STATE OF MARYLAND WELL COMPLETION REPORT

HO-14-0196

**From:** John Boris -MDE- <john.boris@maryland.gov>  
**Sent:** Wednesday, September 02, 2015 12:58 PM  
**To:** Wolf, Kevin  
**Cc:** Collins, Sarah; Steven Krieg -MDE-  
**Subject:** Re: 7175 Pindell School Road Hydrofracture

RE: Well at 7175 Pindell School Road (HO-14-0196)

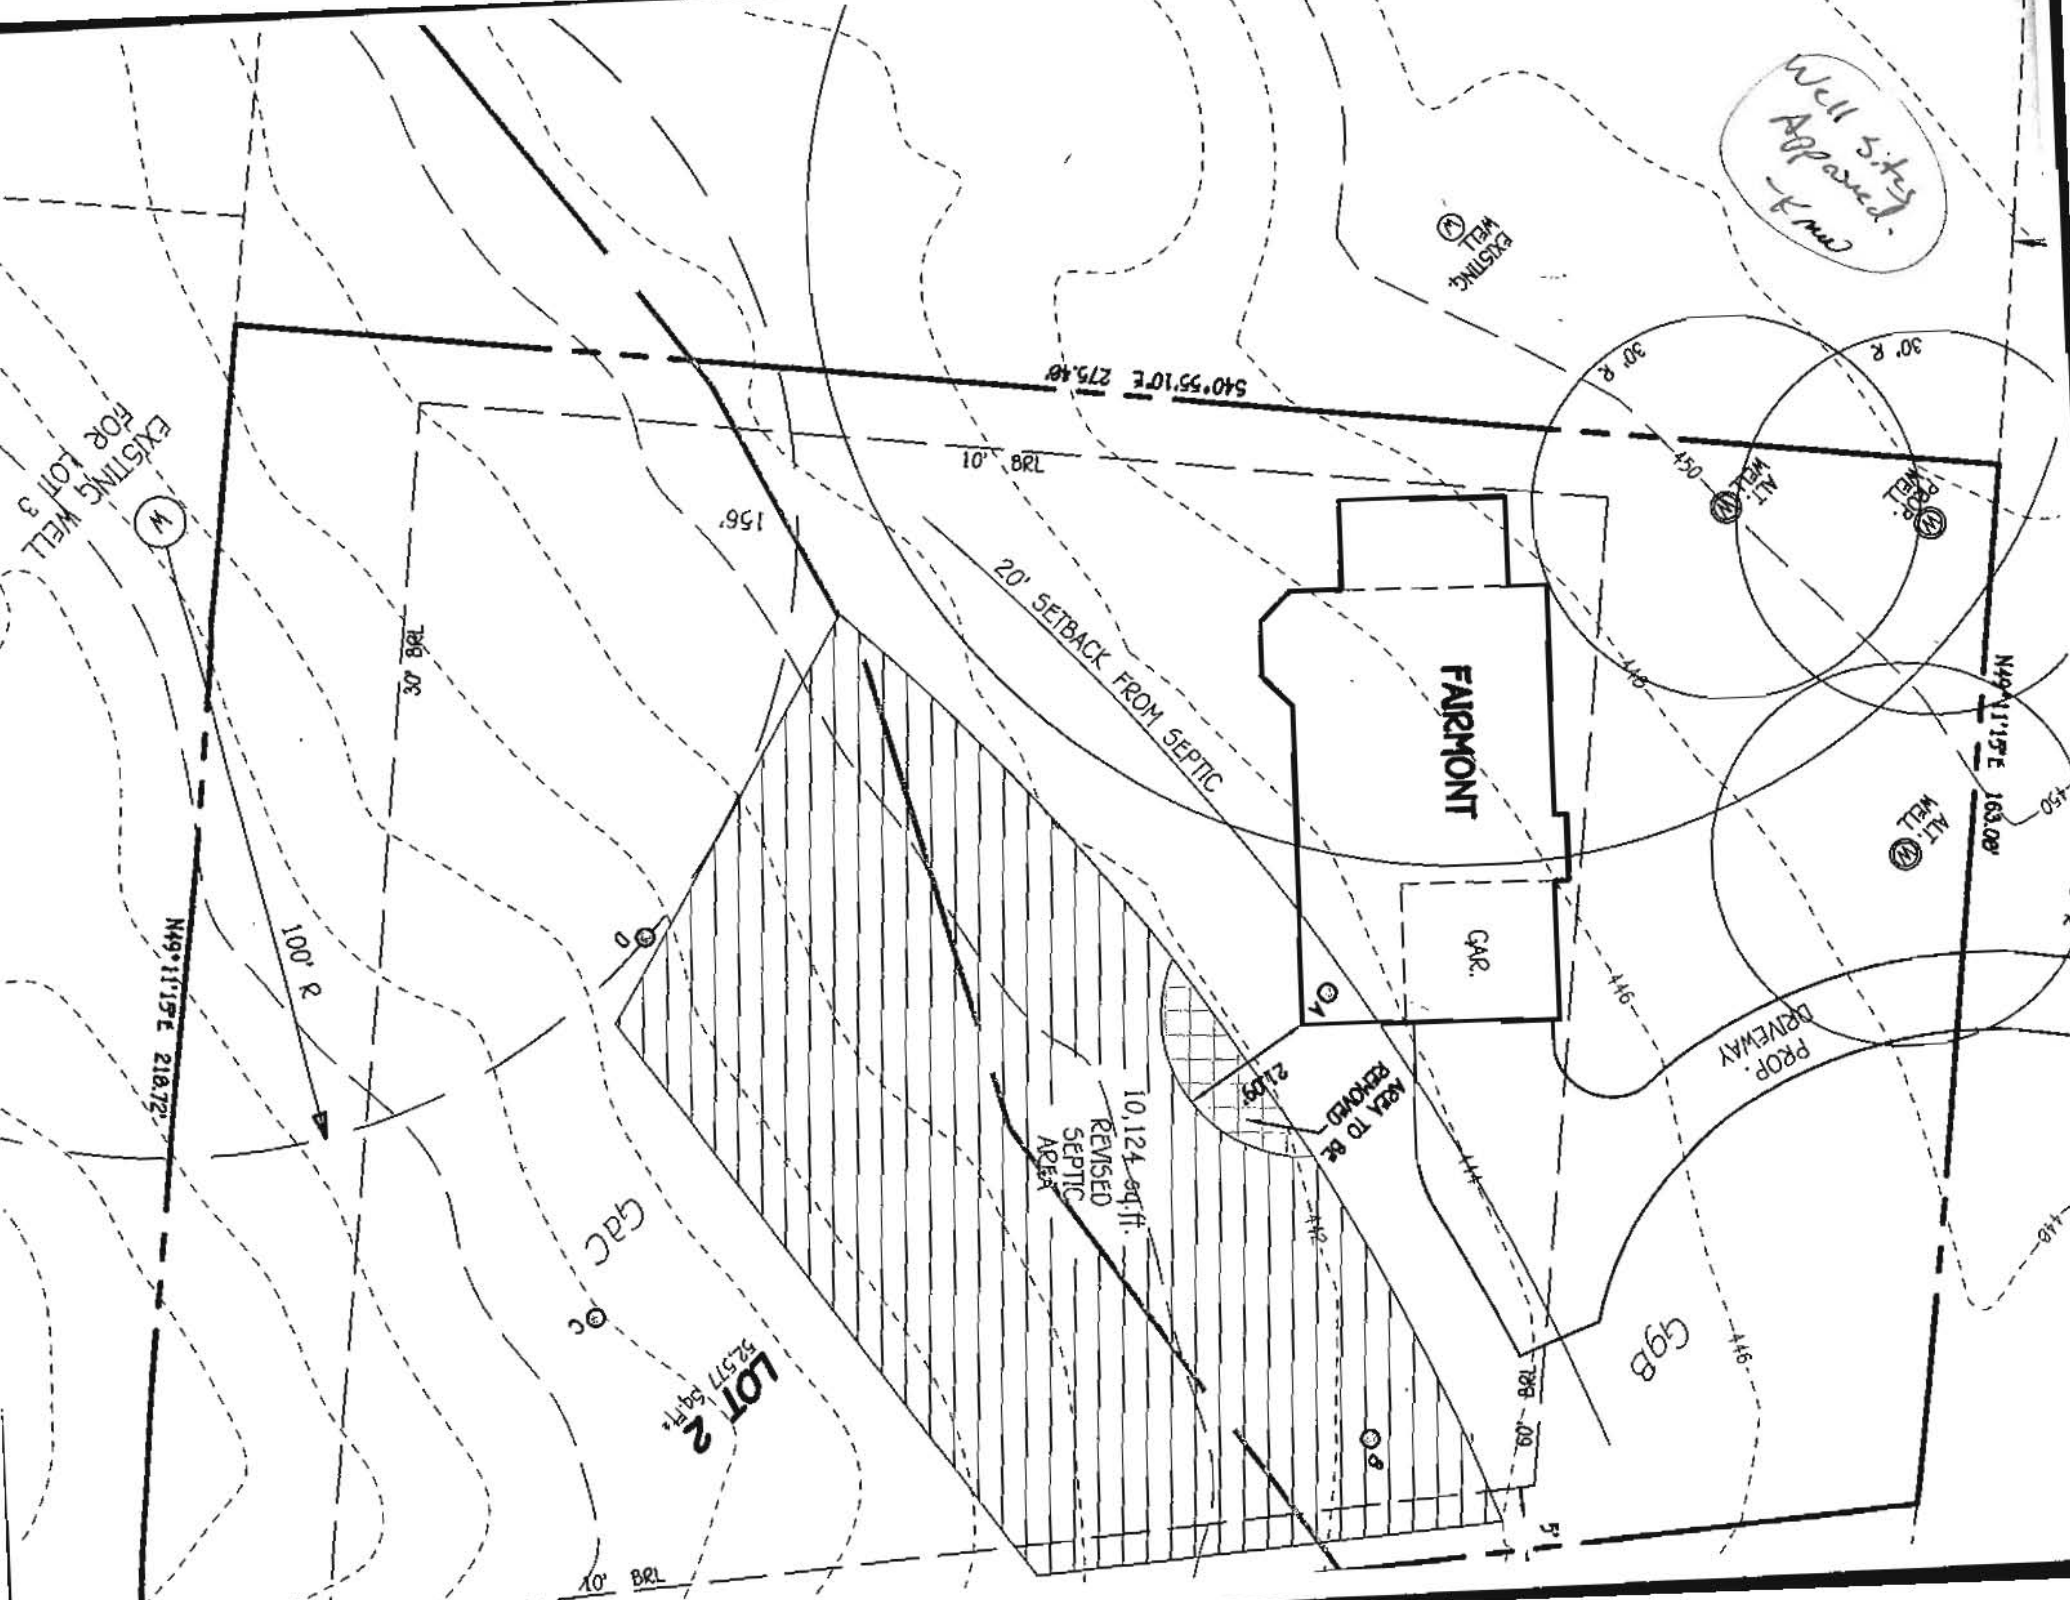
1. Permit was sent in prior to January 19<sup>th</sup> and issued January 21<sup>st</sup>. → Does this adhere to the old regulations or new regulations?

If new regulations, we have several violations here that fall under .28:

2. .28 A notification was not announced.
3. E. within 100' but great than 50' to existing well.
4. I. (2) Frac form states source water was from a well but the well yielded '0gpm' How is this possible?
5. K. No yield test data sheet was submitted but the completion report states 2gpm was pumped for 6hrs = 1000g where the frac report states they used 1000g to frac the well.

How should we proceed? NOV? Ask for a yield test data sheet? Make them re-yield this well showing 1000g of water removed first??

Based on those dates they may have a good argument on this one for not being a violation. Ralph probably signed the contract some time before the regulation went to final. However, how do you yield test a well that did not produce water? We would not have caught that before and maybe not even now. It's hard to punish someone who filled out the form. Honesty still gets you somewhere. If you choose not to send the violation I will follow up with both of them. Regardless of how you proceed I'll need all the information you have. This ones a good one for training.

Since you've asked the question let's just go over this for the exercise. Lots of stuff going on here. First, in regards to the distance I'd ask you to check the Appropriations Permit. They've been special conditioning wells to be 100' apart in certain areas of the Piedmont for new construction. If it's a replacement well, you should special condition the form with your County instructions to notify the HCHD before proceeding. I'm not entirely sure we don't know if it was pumped after the hydrofrac. How would we? They are not required to call in a frac on a new well. That's the importance of knowing what's going on in a certain area from both a setback and hydrogeological perspective. At this point I think the well has sat long enough that we have an equilibrium within the fractures. If someone admits to not pumping it out I would settle for another 6 hour yield test for compliance.
